Subject: **BATTERY COMPARTMENT PLATE**

Model: **PVM-8041Q**

Serial No: **2,000,500 AND LOWER**

*Figure 1*

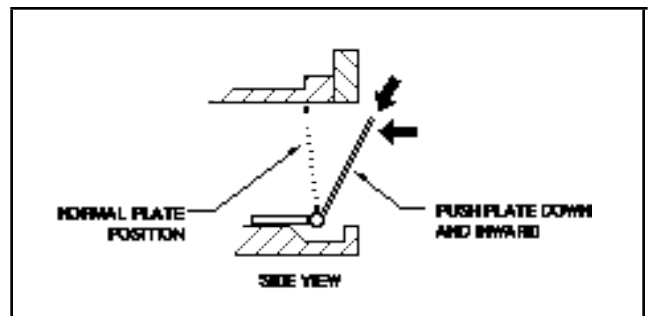
The battery compartment plate may sometimes protrude out of the compartment when the blue tape is removed. To correct this, push the plate down and inward as shown in Figure 1.
